Tennessee Valley Authority  
Regulatory Submittal for Kingston Fossil Plant

Addendum to Ash Stacking Height in Processing Area Work Plan R1  
Geosyntec concurrence with Work Plan and supporting documents

### **ADDENDUM TO ASH STACKING HEIGHT in PROCESSING AREA WORK PLAN** (originally dated June 9, 2009)

Re: Review of Geosyntec's Technical Summary Slope Stability Analysis Results Ball Field Temporary Ash Disposal Site, Kingston Fossil Plant, Harriman, Roane County, TN – AECOM Project No. 60140251

**Attachment A**  
**Stability Analysis – Ball Field Reconfiguration**

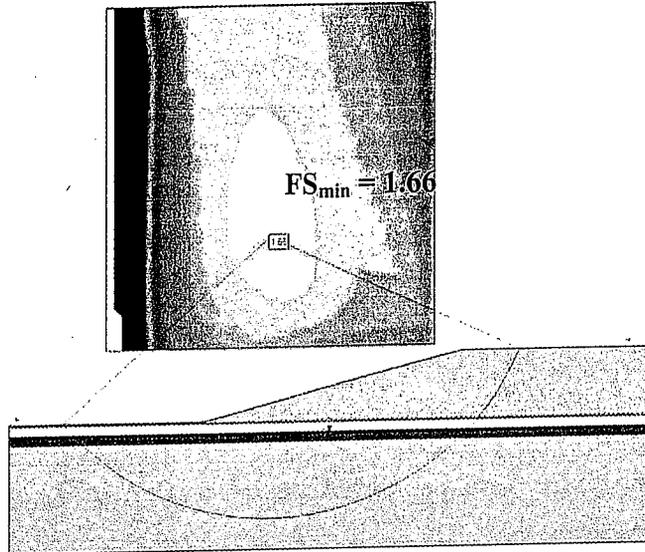
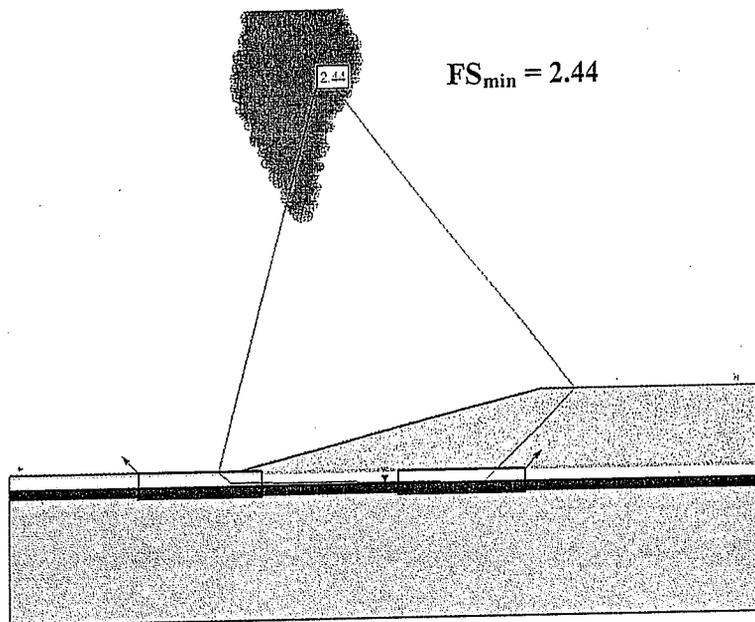
We have reviewed the Geosyntec Technical Summary report and have the following comments and recommendations.

1. The Jacobs Work Plan and/or Geosyntec Technical Summary should include a staging plan with time line and working elevations for the proposed site modifications. We assume no stocked ash will be placed above El. 798 feet, which is approximately 30 feet above the old Ball Field. All parties agreed stockpiles would not exceed 30 feet in height.

2. The Geosyntec Technical Summary does not address the results of instrumentation monitoring program which has been in-place under and along the perimeter of the Ball Field site. Data from this performance monitoring program is important to confirm the assumptions made by Geosyntec in the original site development stability analysis. We understand no new instrumentation is being recommended.

3. There is no discussion on the plan to construct the base ash layer, sand base area at the processing area, and active storage layer (height undefined) all in three to four weeks. We question if the west and north base ash perimeter berms will be filled up to elevation 798 feet in that three for four week time period. We recommend this question be answered prior to mass site regrading. There is no opinion offered on maximum rate of loading to achieve the geometry of the base ash perimeter fill. We understand they are needed to promote better gravity drainage and prevent ponding of water on the stockpiles.

4. There are no recommendations for alarm and action limits for increase in porewater pressure or horizontal movement to settlement of the foundation soils. These levels would trigger either the slowing rate of filling or stop filling. Within the AECOM letter to TVA's Ralph Rodgers dated April 4, 2009, (see attachment) alarm and action level were discussed for limits on the pore water pressure ratio (the change in positive pore water pressure in the foundation ash due stockpile filling which will increase the vertical stress). Our earlier suggestion that pore water pressure ratios not exceed 10 to 15 percent for action and work stoppage, respectively. We assume performance monitoring will continue program of having alarm and action level be maintained to ensure there are limit for the allowable displacement ratio (ratio vertical movement [from settlement plate results] to horizontal movement [from perimeter inclinometer readings]).

5. After reviewing the weekly Instrumentation Results and Summary Reports provided by Jacobs the settlement plates have not been operational since June 25, 2009. With the exception there has been minor movements observed from the inclinometer readings. Why have they not been replaced? More importantly, the monitoring program has not recorded top of stockpile elevation over each or next to each instrument. This allows the geotechnical reviewer to quantify cause and effect. The data summary report should also list the height of fill over the instrumentation at the time of the pore water pressure readings were made and results presented as porewater pressure ratio. We understand that the porewater pressures transducers readings are recorded continuously, without fill reading. We suggest that at the end of day the height of fill reading be taken by surveyors at the five instrumentation stations. This is needed to compute the agreed upon pore water pressure ratio limits.

6. The Technical Summary by Geosyntec does not provide a discussion of the recommended rate of filling for the "base ash layer" during mass regrading of the site.

7. We encourage the construction of drainage ditches, access roads, sand base drainage layer, area and that the base ash layer can commence along the north side of the site as this is where the Initial North Dike was located. We understand that the North Dike was founded on the natural alluvial soils and will provide lateral resistance to movement of the foundation ash during base ash filling.

**Geosyntec Response:** AECOM is correct regarding the height of the proposed stockpiles. In the Jacobs proposal, no stockpile will exceed 30 feet in height above the demarcation layer, as shown in the Jacobs plan drawing of the proposed modification presented in Attachment A. In discussions with Jacobs personnel, Geosyntec understands that over the course of the past several months, numerous small and local stockpiles have been placed across the Site, but that in general, almost all portions of the Site (and certainly the center portions of the Site) have experienced temporary stockpiles of at least 15 to 30 feet in height. There is currently 5 to 15 ft of ash over the majority of the Site. During the ongoing ash placement activities, the existing instrumentation network has been monitored to assess the response of the underlying foundation ash to the imposed loading from the temporary stockpiles. There has been little indication of excess pore pressure response, implying that the filling rate has been sufficiently slow such that the imposed excess pore pressures have rapidly dissipated. Additional discussion of instrumentation follows. The proposed Jacobs plan essentially calls for a regrading of the existing layer of ash (i.e., the base layer) over the demarcation layer to construct the "base layer." Much of this material is currently in place and the proposed plan is to prepare a relatively smooth lift of ash above the demarcation layer, not bring in significant quantities of new ash. Therefore, there is likely to not be significant "rapid base ash filling" over the next few weeks. Rather, the base filling will be primarily to establish and incrementally add and/or relocate ash to construct a relatively uniform working platform over the demarcation layer to facilitate drainage and to provide protection for the instrumentation network.

**Geosyntec Response:** To date, Geosyntec has not prepared a formal written summary of the instrumentation response. Mr. Shannon McKammey, P.E., of Jacobs provides a weekly summary assessment of the instrumentation network response for internal review. A copy of the Jacobs summary is provided to Geosyntec. In general, as stated above, there is little indication of excess pore pressure development as a result of loading from the ash. The ability to continuously monitor pore pressures using these piezometers provides definitive information that the piezometers respond to changes in ground water levels across the Site that may be more regional in origin. This ability to continuously monitor the instrumentation network also provides confirmation that there is very little indication of excess pore water pressure development. Given the broad distribution of

**Geosyntec Response:** AECOM is correct regarding previous discussions regarding the need, use, and value of appropriate alarm or trigger levels. Geosyntec has maintained the alarm levels referenced in the AECOM comment (i.e., 10 percent for action and 15 percent for work stoppage) throughout the project. Furthermore, Geosyntec will continue to maintain these alarm levels as the project moves forward. To date, there has been virtually no indication that the pore pressure ratio exceeds even 1 percent.

**Geosyntec Response:** One of the reasons for the construction of the proposed base layer is to provide additional protection to the buried conduit and water lines that comprise the instrumentation network. Geosyntec has made several trips to the Site and met with Jacobs personnel to develop a plan for initiating and completing repairs. Unfortunately, the ongoing operations, the thickness of the existing "base" layer of ash, and the recent heavy precipitation has prevented the team from completing the repairs. We have recently developed plans to allow access to the instrumentation and to complete the repairs. We hope to have the repairs complete by mid-December. With regards to the recommendation to perform field surveys at the end of each day, Geosyntec does not feel that this is necessary for the following two reasons: (i) it is anticipated that the "stockpile height" above each instrument cluster will change continuously and that achieving a representative correlation between fill height and instrument response will be extremely variable and potentially unreliable; and (ii) the fact that much of the Site has experienced stockpile heights of >20

**Geosyntec Response:**      Please see the response to previous comments regarding the filling rate. As part of this response, however, Geosyntec has performed supplemental slope stability analyses to assess the sensitivity of the calculated slope stability to increasing pore pressure ratios. Results are provided in Attachment B. These results indicate that even with pore pressure ratios as high as 25 percent, an adequate calculated factor of safety is provided. Geosyntec notes that the conditions at the Site (i.e., the Ball Field Site) have been confirmed to be much more favorable than conditions in the Dredge Cell area that does not exhibit the relatively stiff crust layer. While Geosyntec concurs with AECOM that slope stability is and should be a major concern, the combination of the installed prefabricated vertical drains and the stiff crust explain why the Ball Field Site shows a much more “subdued” response to loading, compared to other portions of the KIF site being studied by AECOM.

**Geosyntec Response:** Geosyntec concurs with this recommendation and believes that any and all efforts to control and divert surface water to perimeter ditches will be beneficial. Therefore, we believe that implementation of the Jacobs proposed modification should be approved, including ditches, access roads, etc on the west side of the Site.

Construction Sequencing

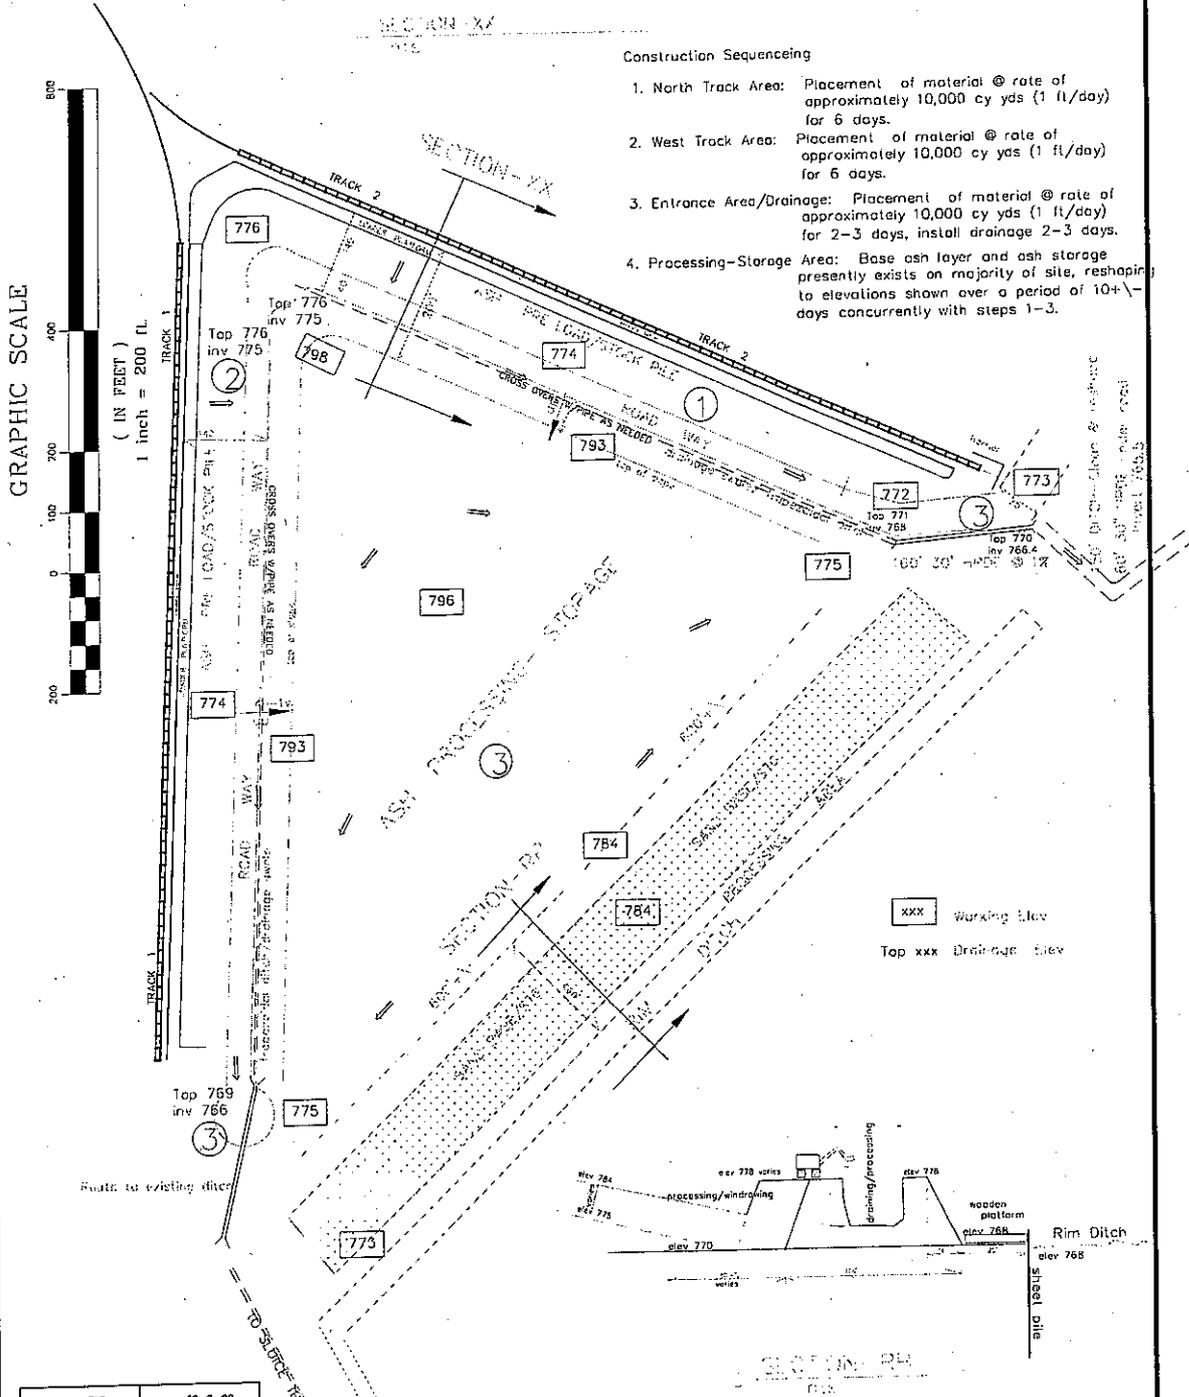
1. Provide a sequence of construction time line or schedule to show when and how the working grades will be achieved. We are concerned about rapid base ash filling up to the working grades in less than four weeks without performance monitoring and sign-off by Geosyntec, the engineer of record for this work area.

1. North Track Area: Placement of material @ rate of approximately 10,000 cy yds (1 ft/day) for 6 days.
2. West Track Area: Placement of material @ rate of approximately 10,000 cy yds (1 ft/day) for 6 days.
3. Entrance Area/Drainage: Placement of material @ rate of approximately 10,000 cy yds (1 ft/day) for 2-3 days, install drainage 2-3 days.
4. Processing-Storage Area: Base ash layer and ash storage presently exists on majority of site, reshaping to elevations shown over a period of 10+ days concurrently with steps 1-3.

### Stability Analysis for Ball Field Reconfiguration (Excess Pore Pressure Condition)

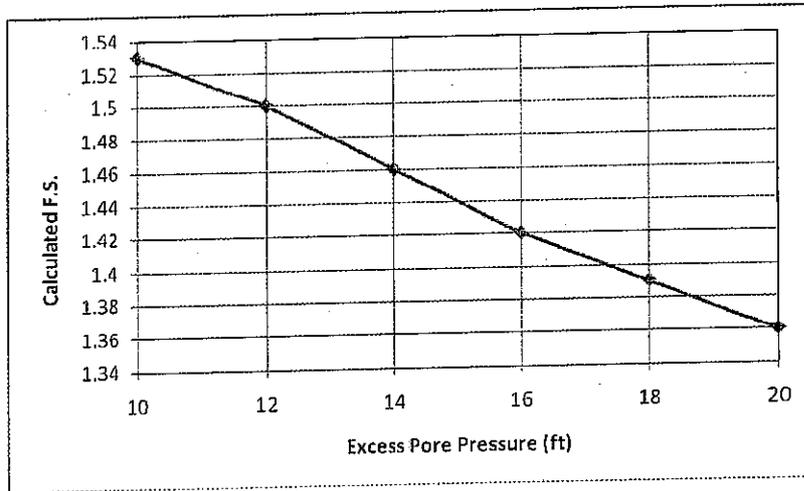
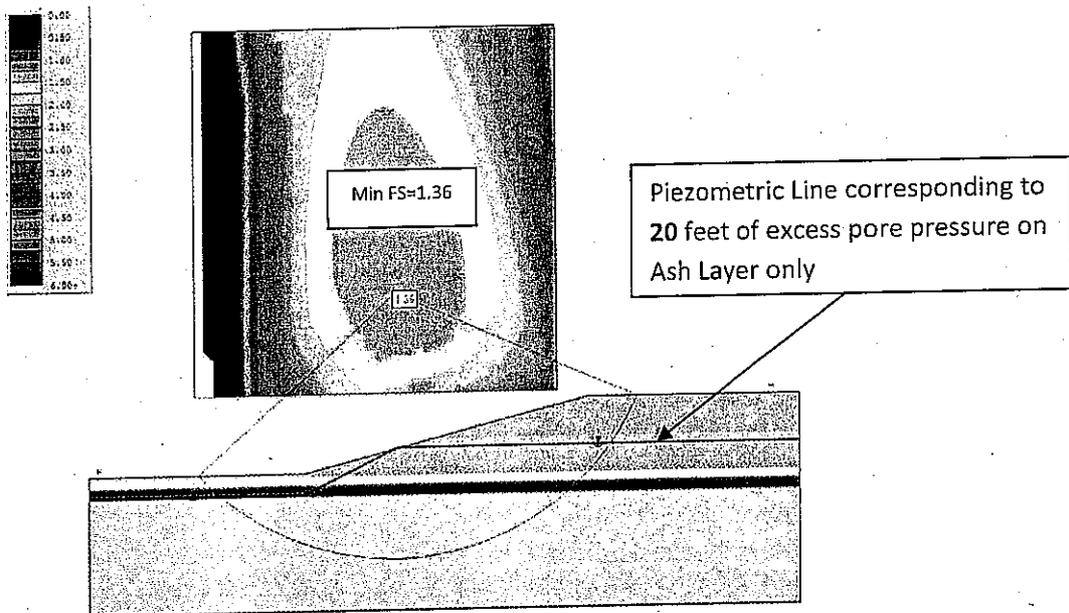
5. Update the stability analysis to include varying porewater pressure ratios.
6. Commence with the construction of drainage ditches, access roads, sand base layer and base ash filling over the north side of the site as this is in the area is protected by wick drains and the former North Dike foundation.

Excess Pore Pressure in the Lower Ash (ft)	Excess Pore Pressure Ratio	Calculated FS
10	0.21	1.53
12	0.25	1.50
14	0.29	1.46
16	0.33	1.42
18	0.37	1.39
20	0.42	1.36
